FROM: AMHI Center Building Storage Addendum 2
TO: Prospective Bidders, Suppliers, and Other Parties
RE: Addendum No. **2 (Two)** to the Bidding Documents

AMHI Center Building Storage, Augusta ME

ADDENDUM 02 - 10.27.2021

A1.13

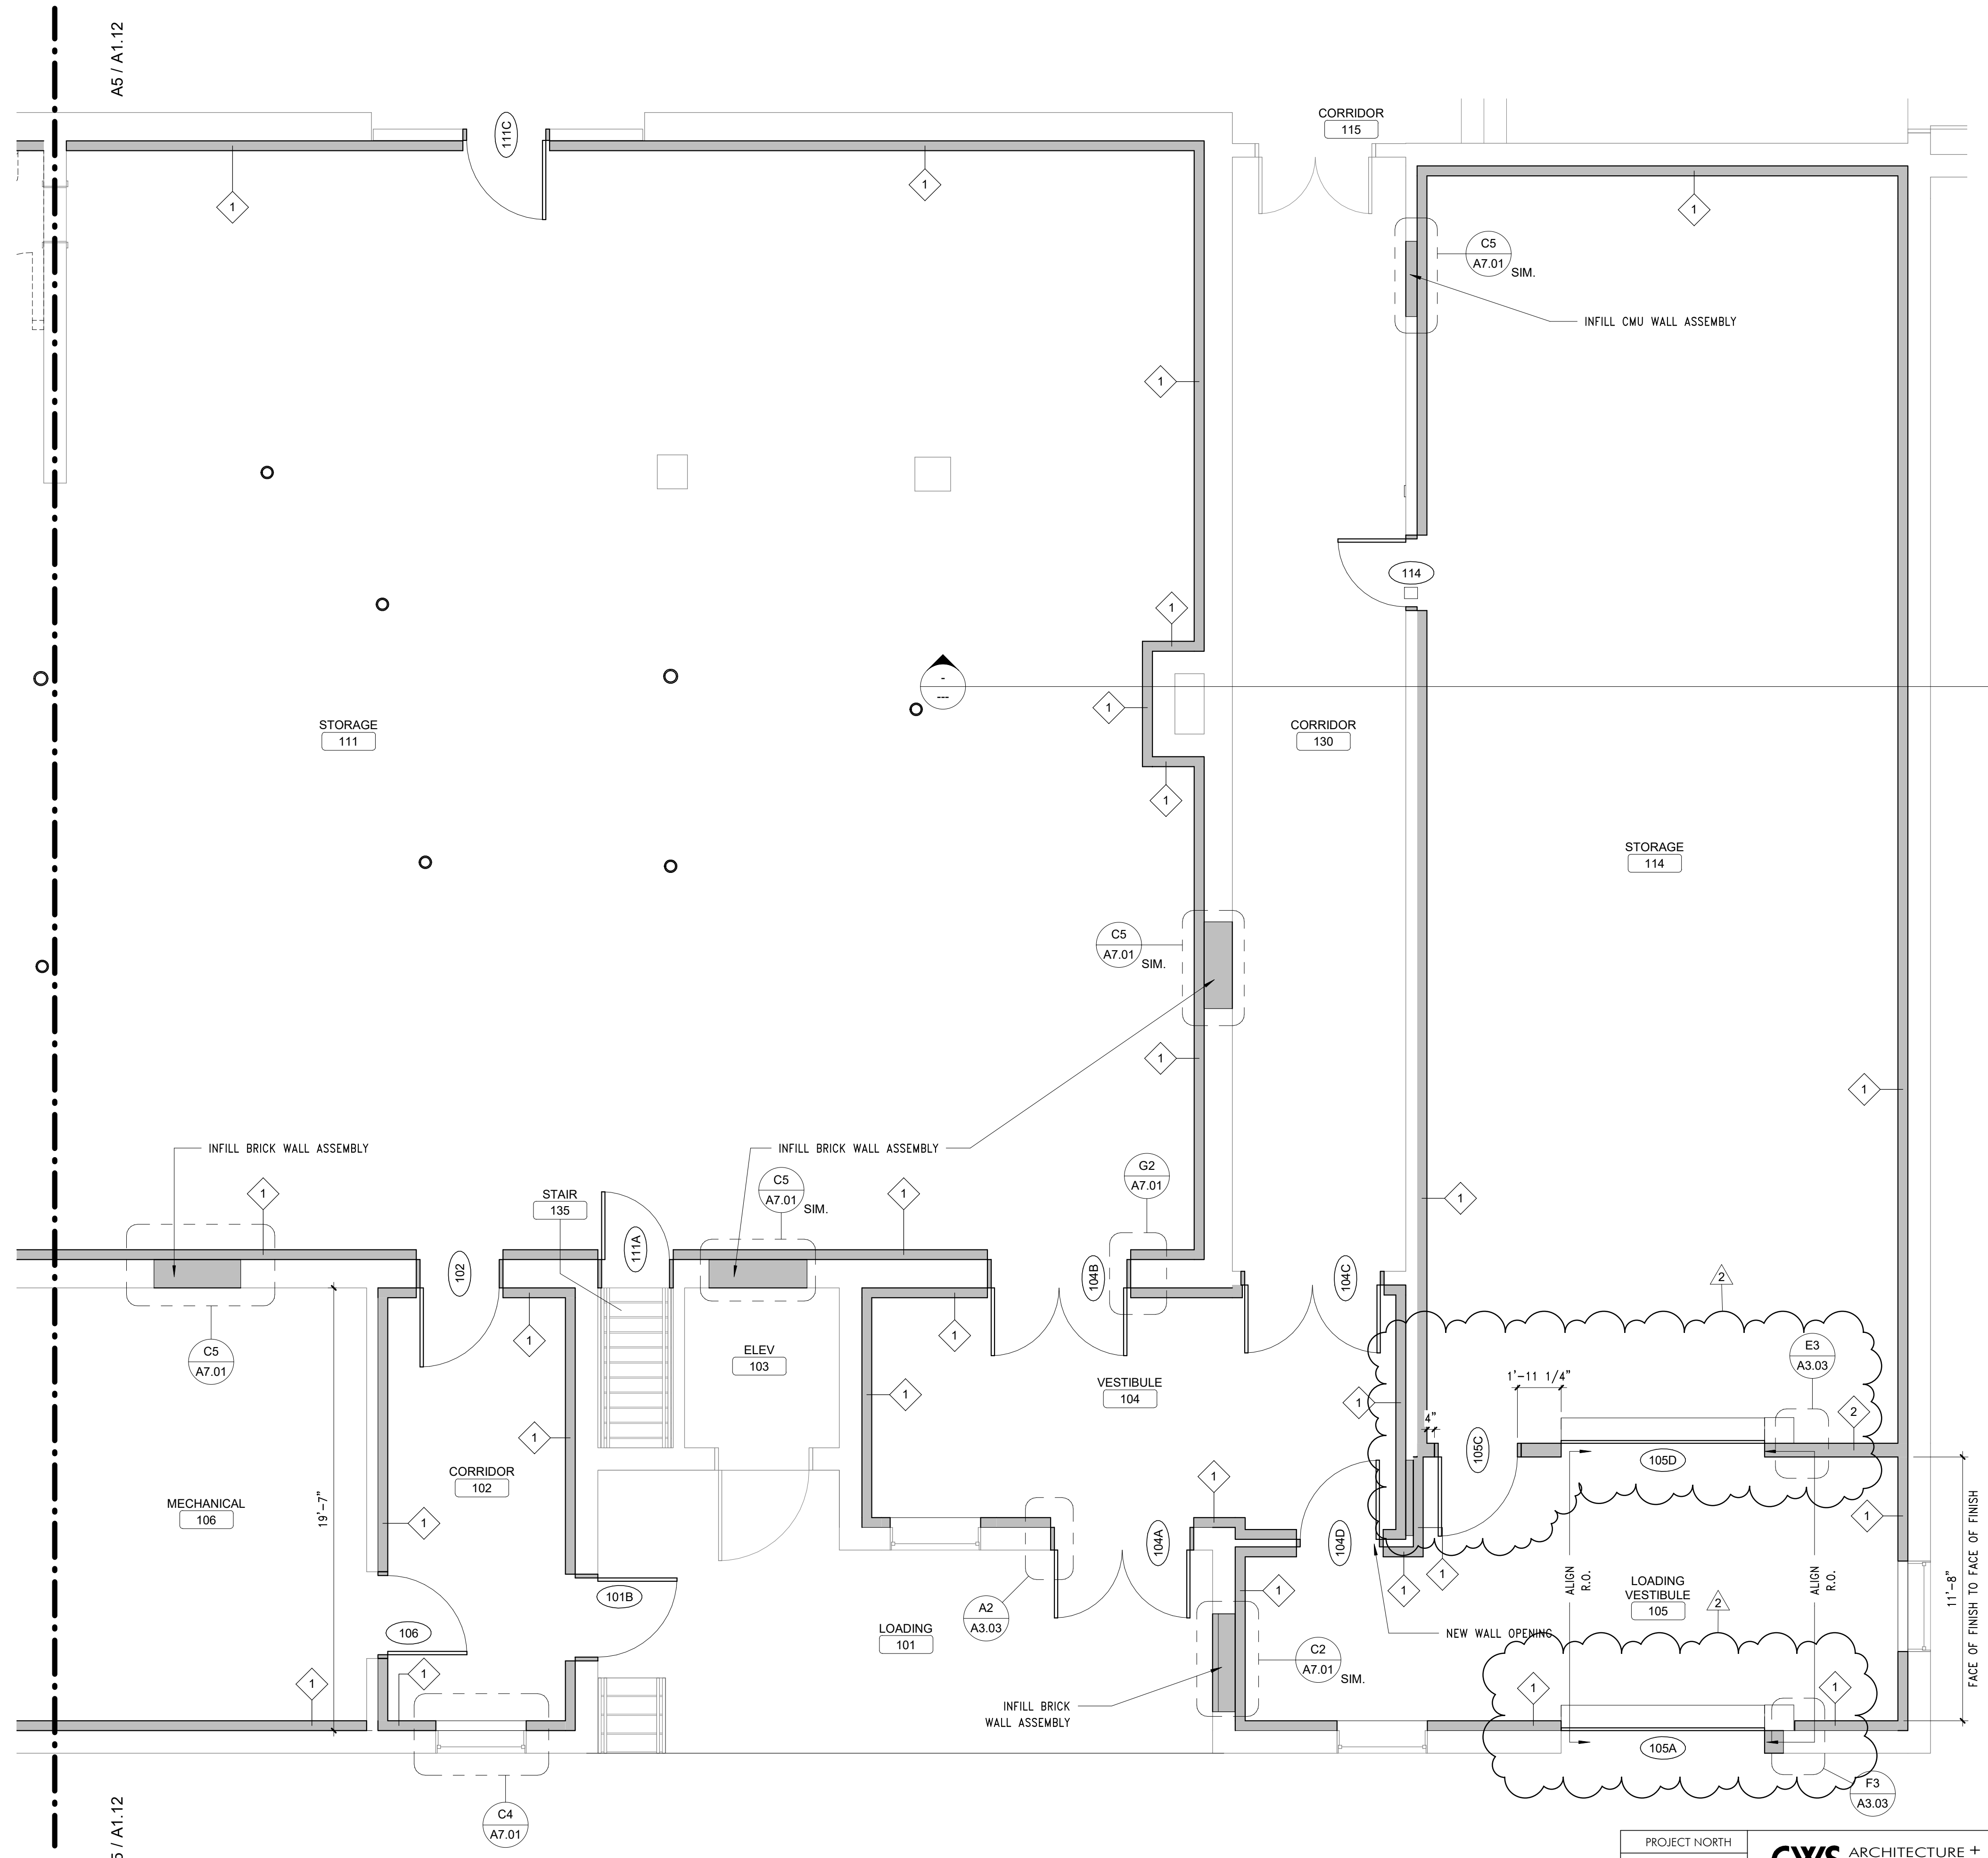
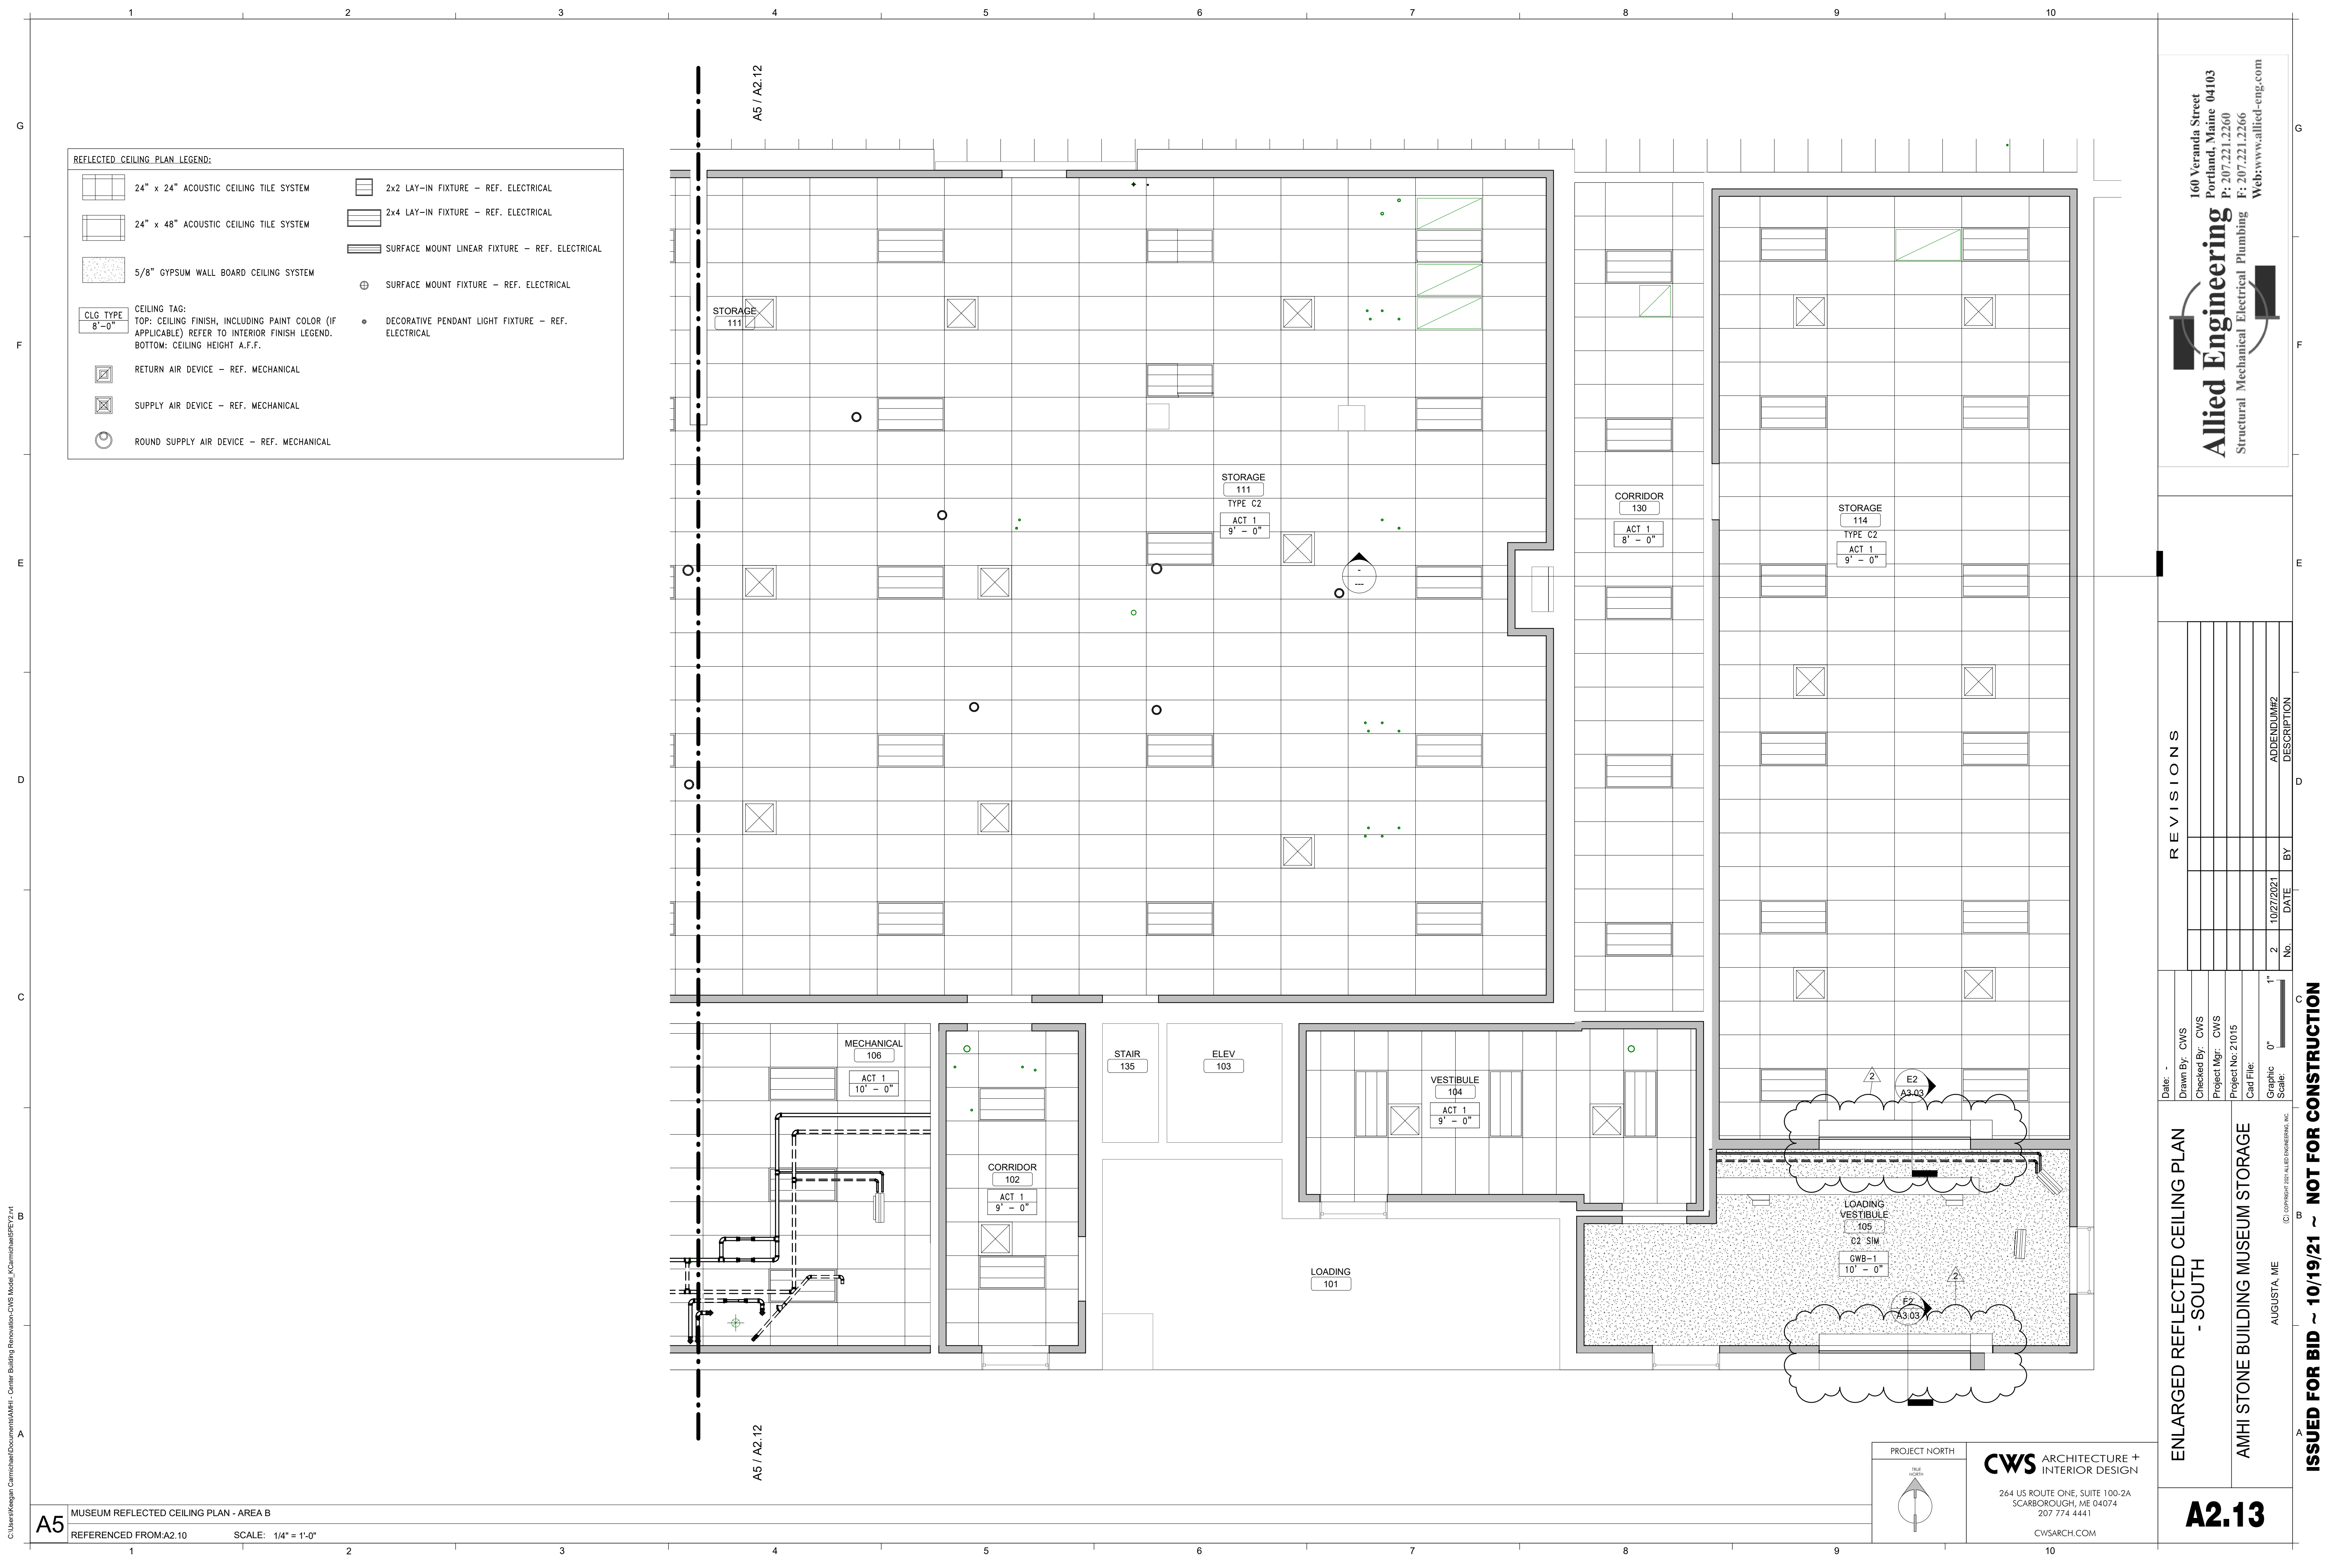
1. **SHEET G-000**– **ADDED** sheet SF-400 – STRUCTURAL-ENLARGED FRAMING PLAN AND DETAILS
2. **SHEET AD1.13**– **MOVED** Overhead door moved 16” west
3. **SHEET A1.13** – **MOVED** Overhead door moved 16” west
4. **SHEET A2.13**– **MOVED** Overhead door moved 16” west
5. **SHEET S-000** – **ADJUSTED** limit of AREA-B loading
6. **SHEET SF-100** – **ADJUSTED** Limit of tractor travel, **ADDED** enlarged plan D6/SF-400
7. **SHEET SF-110** – **REPLACED** Note 1 of the ROOF AND EXTERIOR FAÇADE CONDITIONS
8. **SHEET SF-200** – **REPLACED** Note 1 of the ROOF AND EXTERIOR FAÇADE CONDITIONS
9. **SHEET SF-201** – **REPLACED** Note 1 of the ROOF AND EXTERIOR FAÇADE CONDITIONS
10. **SHEET SF-400** – **ADDED** Sheet in its entirety
